Mitigation Plan

Lake Wendell Mitigation Project

FINAL VERSION

Addendum to Mitigation Plan

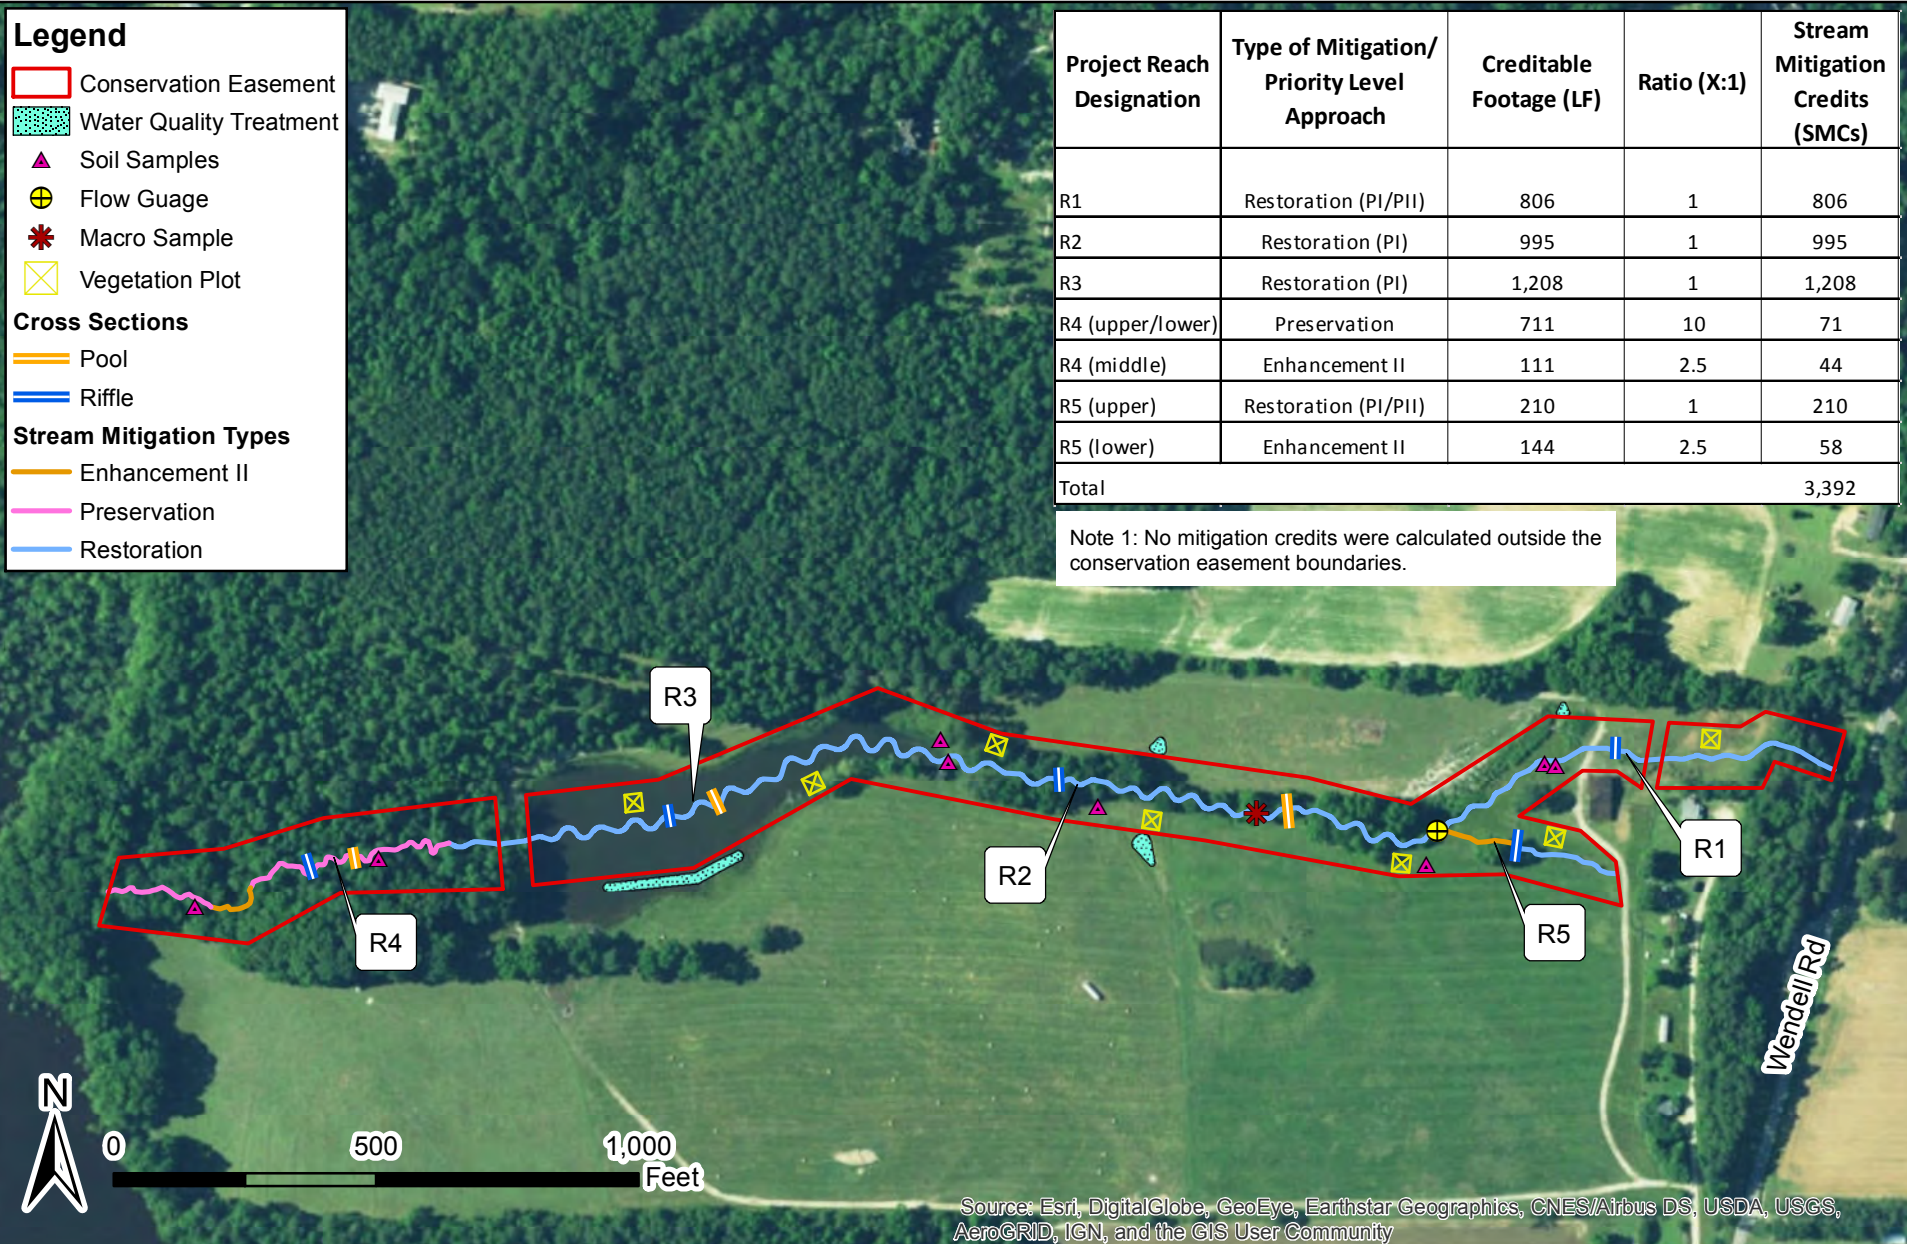
6. A stream gauge should be placed in upper R1 and in upper R5 (above riffle cross-sections).
7. Figure 10 shows R5 as EII only, however, in the table inset as well as other areas in the document lists some restoration and EII work.

7. Figure 10 shows R5 as EII only, however, in the table inset as well as other areas in the document lists some restoration and EII work. Response: Figure 10 has been revised to clarify the proposed R5 Stream Enhancement Level II (Lower) and Stream Restoration (Upper) segments as further described in Table 1 and Section 6.1.2 of the mitigation plan.

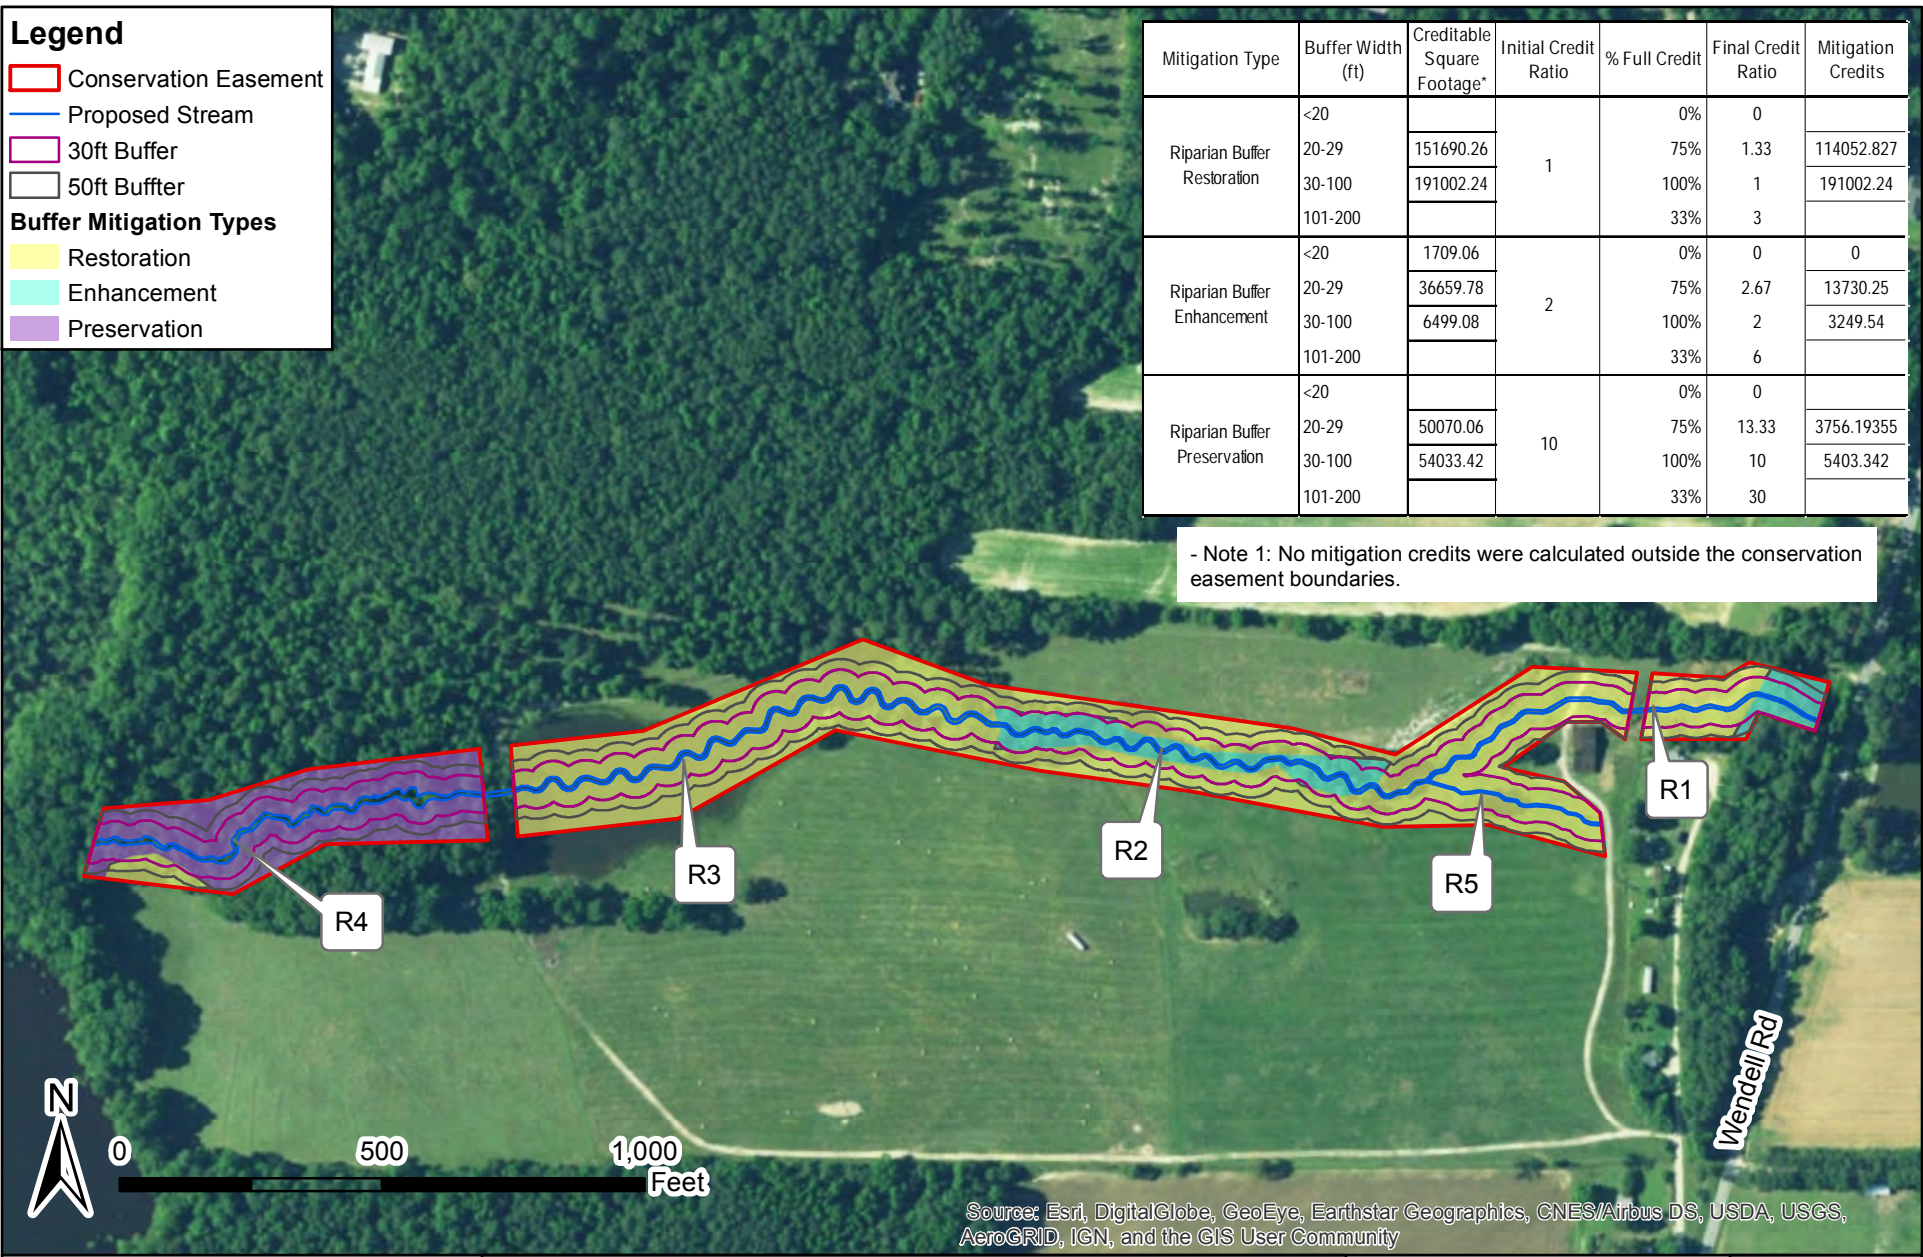
It was discovered that the Riparian Buffer credits were calculated for lower ratios erroneously in the revised Mitigation Plan. This occurred because the calculated areas of buffer between 20-29' were erroneously listed as having lower ratios, although the majority of eligible buffer features all exceed 30' width total.

The total enhancement area is 48,180 sf. There are 3,328 sf of buffer with less than 30' width at top of project stream left and this was subtracted from credit.

- Figure 11 has a statement about all areas being within 30-100', while other places in the Mitigation Plan state there is nothing less than 50', or nothing less than 30'. Please clarify.

- Figure 11
 - Clarify widths to justify the 1:1 & 2:1 ratios. Here is an example

The acreages were summed corrected as shown below. All areas of riparian buffer credit shown below have buffer widths greater than 30 feet. This will be updated in the As-Built Report.

- **Figure 11 has a statement about all areas being within 30-100', while other places in the Mitigation Plan state there is nothing less than 50', or nothing less than 30'. Please clarify.** WLS Response: Table 1, Figure 11, the Revegetation Plan (plan Sheets 15 through 18), and the appropriate mitigation plan text have been edited as suggested for clarification and to provide more transparency with regards to the proposed riparian buffer mitigation limits, ratios, and credits, and are included in the Final Mitigation Plan.

- **DWR Comment: Clarify widths to justify the 1:1 & 2:1 ratios. Here is an example.** WLS Response: Table 1, Figure 11, the Revegetation Plan (plan Sheets 15 through 18), and the appropriate mitigation plan text have been edited as suggested for clarification and to provide more transparency with regards to the proposed riparian buffer mitigation limits, ratios, and credits, and are included in the Final Mitigation Plan.

SHEET NAME
R1&R2
PLAN AND PROFILE
 SHEET NUMBER
9

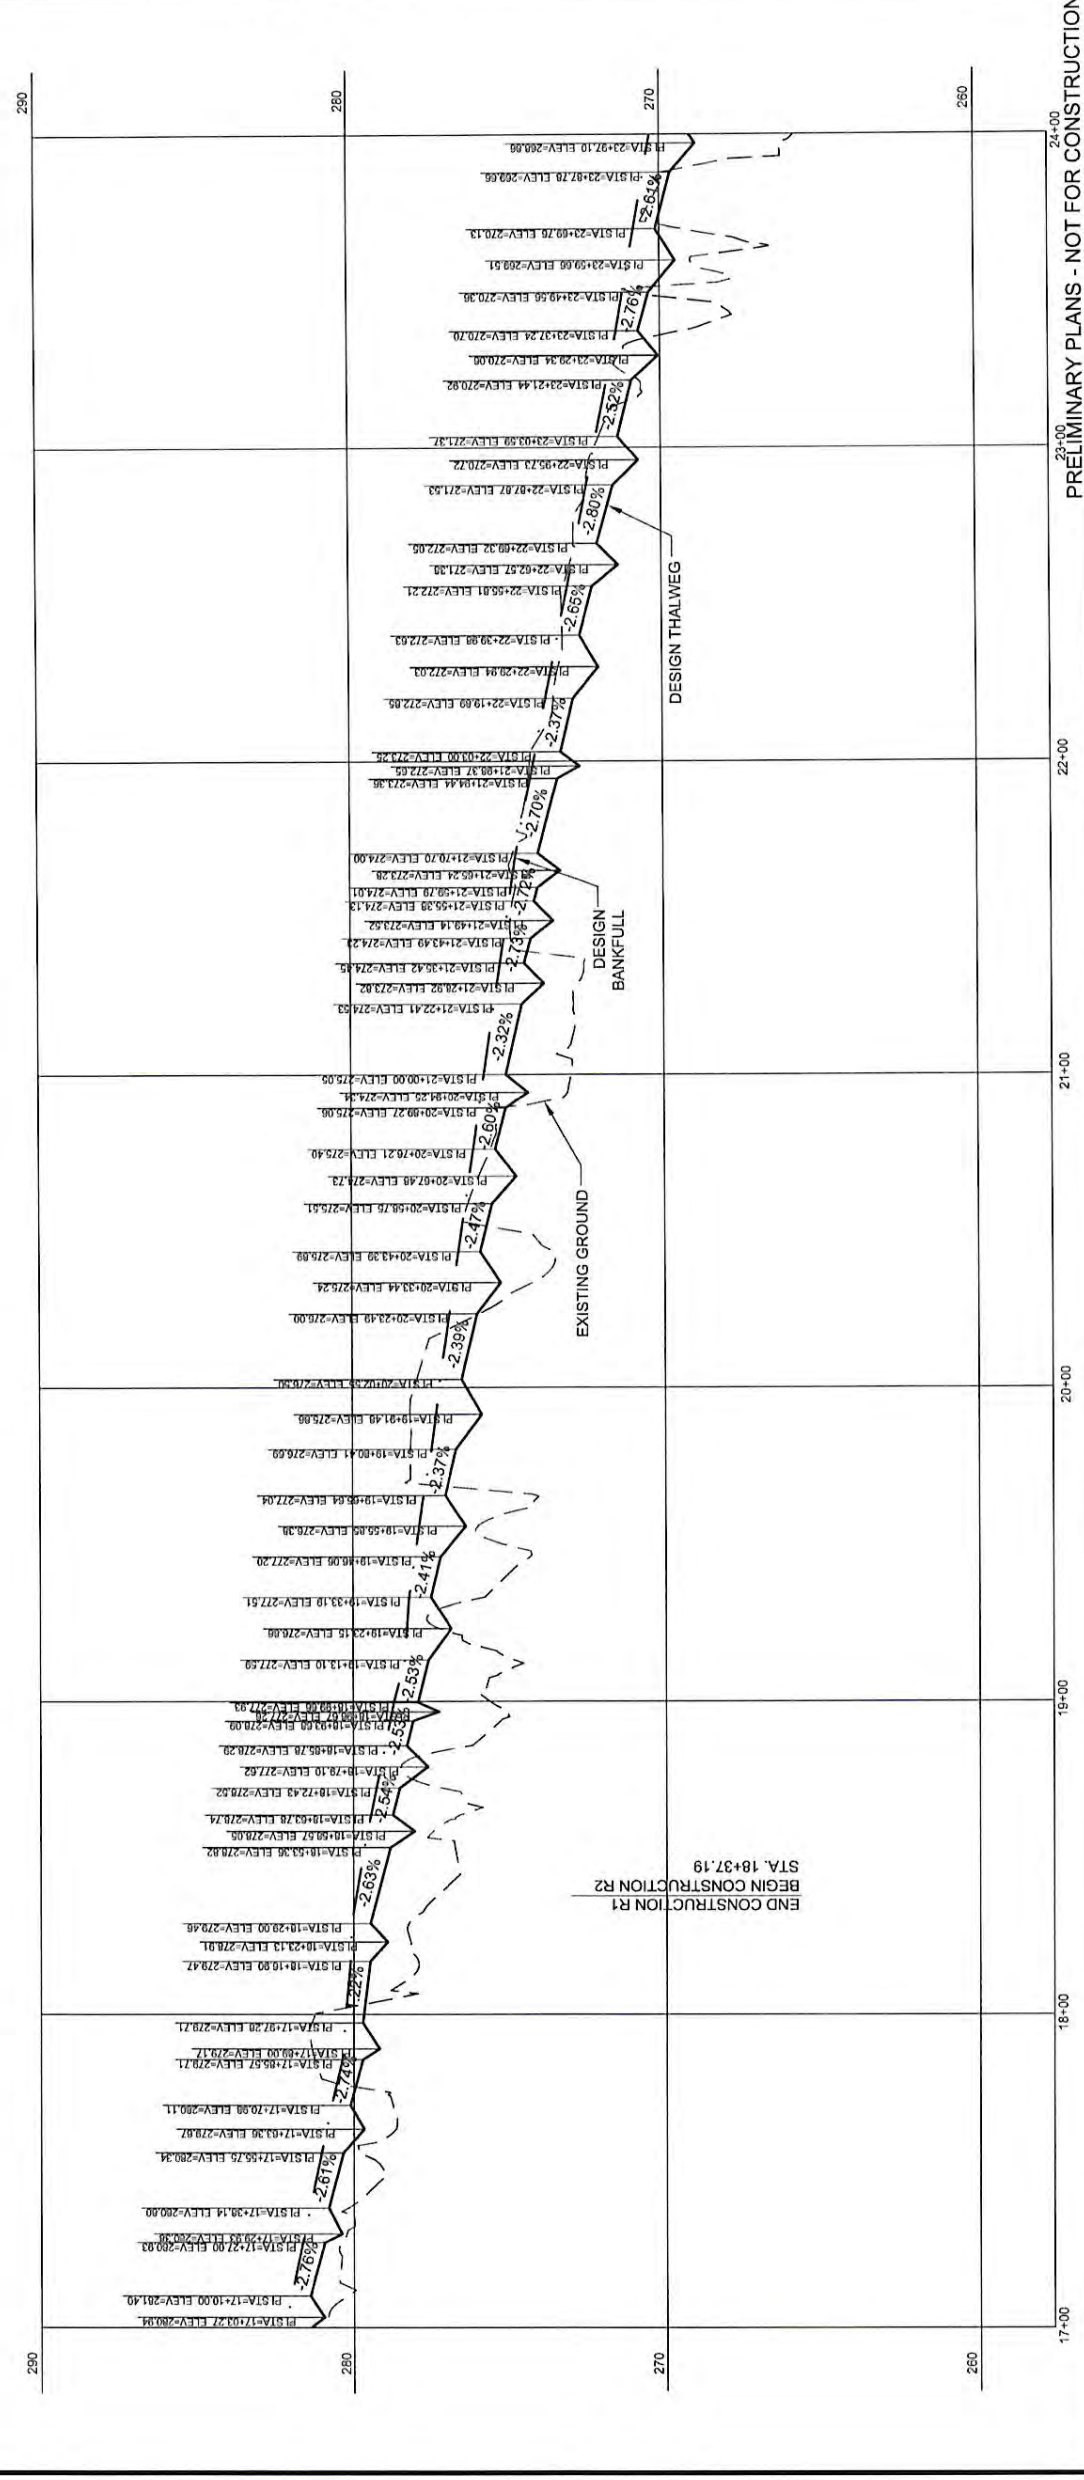
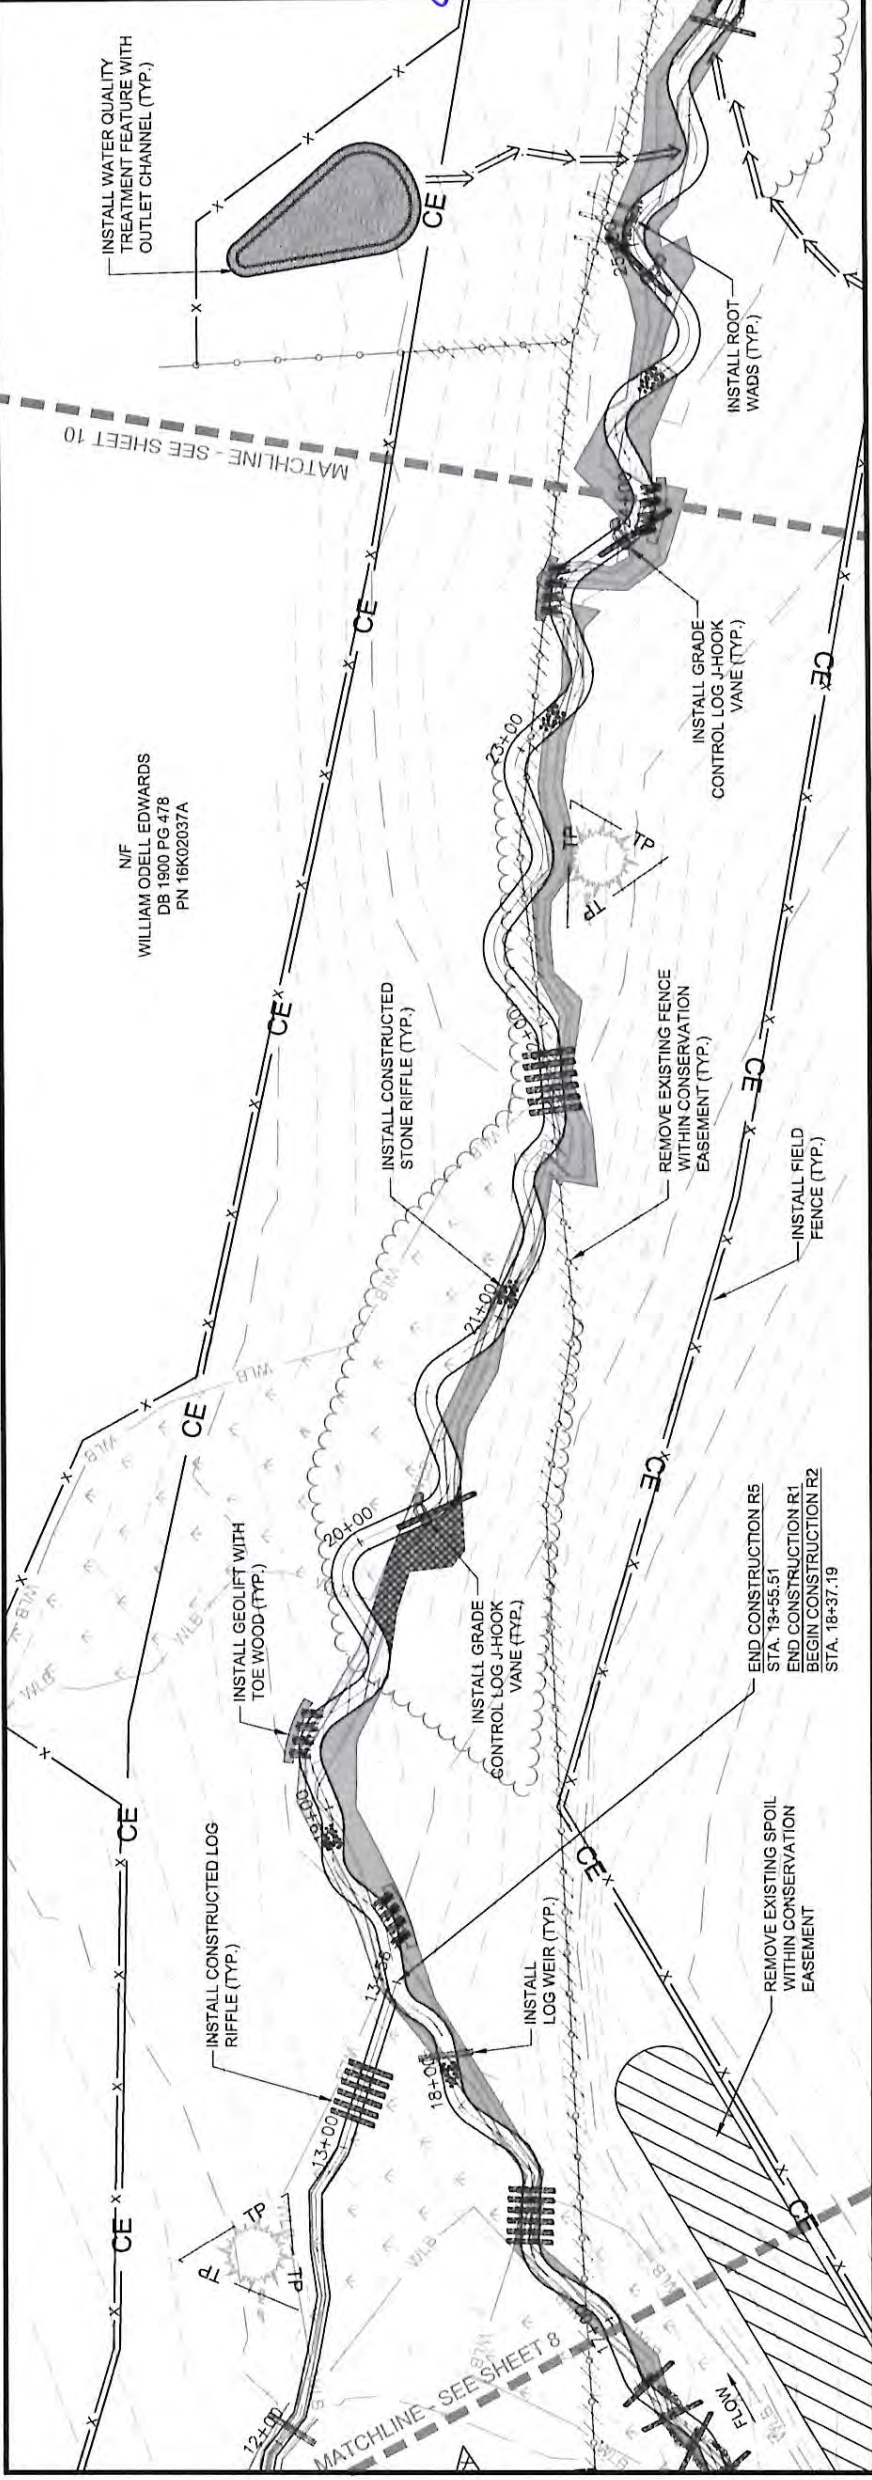
9. DWR likes the depressional water quality features, however, for those features outside of the easement, how will they be protected? Managed?
10. For the water quality features located outside of the easement, Design sheets 9 and 10 show that these features will include an outlet channel which shows it discharging down to the stream. DWR would prefer that the outlet channel discharge into a mounded level spreader somewhere in the riparian buffer so the flow will have a chance to dissipate before entering the stream. Or these channels could discharge into a constructed vernal pool which would then dissipate the flow energy from the outlet channel.

10. For the water quality features located outside of the easement, Design sheets 9 and 10 show that these features will include an outlet channel which shows it discharging down to the stream. DWR would prefer that the outlet channel discharge into a mounded level spreader somewhere in the riparian buffer so the flow will have a chance to dissipate before entering the stream. Or these channels could discharge into a constructed vernal pool which would then dissipate the flow energy from the outlet channel. Response: WLS understands the concern of installing these outlet channel features that discharge into the regulated Neuse River buffer. The water quality treatment features and their corresponding outlet channels are proposed along non-jurisdictional flat or depressional areas where existing small ephemeral drainages (drainage areas ave. 3 to 7 acres) intersect with the proposed conservation easement/restored stream and riparian buffer corridor. The proposed outlet channels are intended to replace and improve the existing degraded ephemeral channels, at the same locations, to provide a stabilized connection to the restored stream system for the existing concentrated ephemeral flow path. It is anticipated that over a few growing seasons post-construction, these small conveyance swales will become heavily
